WESTERN AREA PLANNING COMMITTEE 22ND JULY 2020

UPDATE REPORT

Item (3) Application 20/00612/FULD Page No. 55-70

Site: Riverbend, Upper Eddington, Hungerford, RG17 0HH

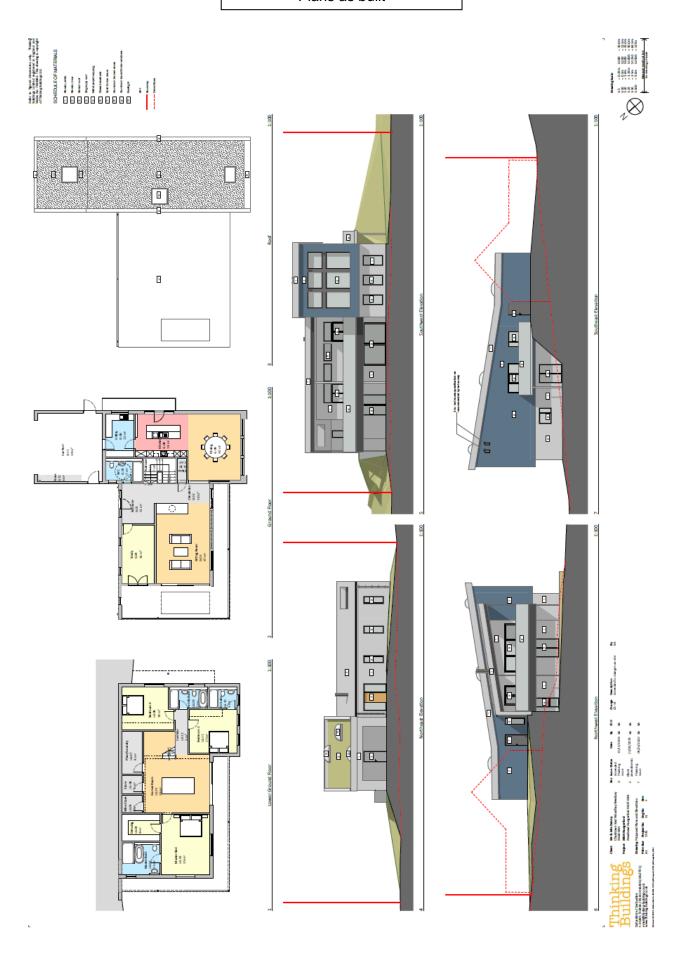
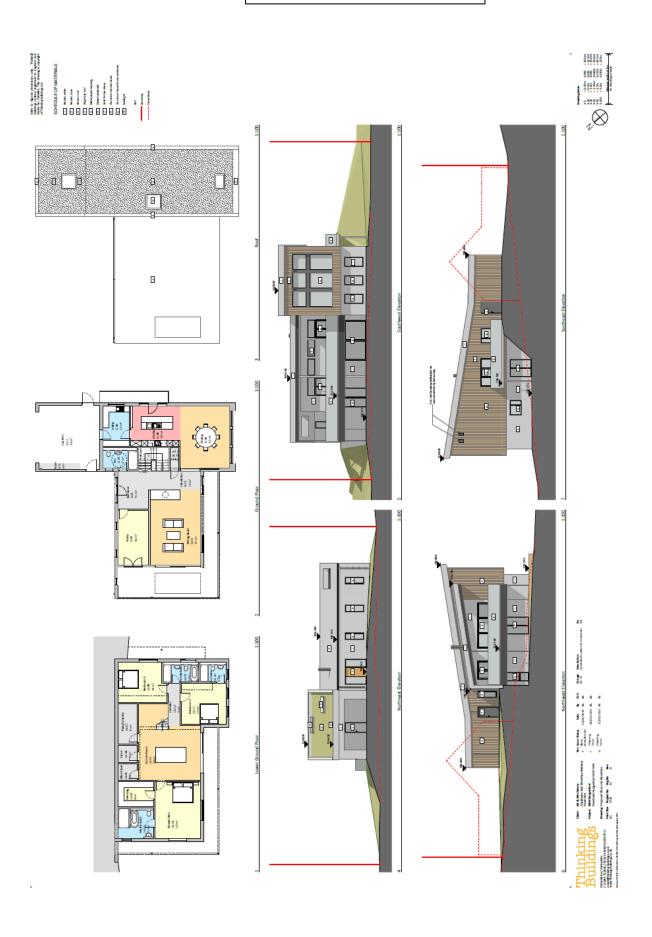
- 2 further representation letters since agenda publication. Matters raised:
 - Error on the amended proposed elevation drawing 11G that the key with the schedule of materials refers to the blue render but the drawing shows cladding;
 - The amended proposed site plan and sections shows trees outside the boundary of the owned land to the north-west of the site in the adjacent farm field where no trees are currently planted. How can these be added to an area not owned or controlled by the applicant?;
 - The land to the south of the river is a very valuable riparian landscape together with extensive area (some 55 acres) of original wetland with great potential for sensitive conservation and management as a wetland nature reserve, the tree felling has introduced Riverbend into this landscape to intrusive and

The matters which have drawn the greatest concern are the external materials, tree felling/landscaping on site, and height including the depth of the fascia. Other issues such as the roof lights, extension of the balcony, and removal of the slated screening on a side elevation might be considered minimal individually, however the concerns raised are that collectively they alter the appearance of the originally approved dwelling.

With regard to the 600mm rather than 300mm fascia depth, the continuation of the balcony screen on the side elevation towards the field rather than timber slats it is understood these are ongoing concerns regarding the design of the dwelling. More extensive works to the roof would be required to lower the fascia height from the top, particularly as it is part of the lip of the roof in which the sedum would be planted to the garage element of the building.

The changes to the external materials shall be completed within 6 months of the date of this permission. Notwithstanding the annotations, fascia depth, and balcony on the northwest elevation on drawing 11 Rev G received on 1 June 2020 the external materials shall be:

Vertical larch cladding to the upper level, (where parts of the building are currently painted blue), and the larch cladding shall be natural and not colour painted;

White coloured render to the lower level and inset areas on the upper level (which are not currently painted blue);

Anthracite coloured fascia and balcony balustrade;

Flat/flush roof lights;

Fascia depth of 300mm;

Timber slats to the balcony on the northwest elevation outside the study;
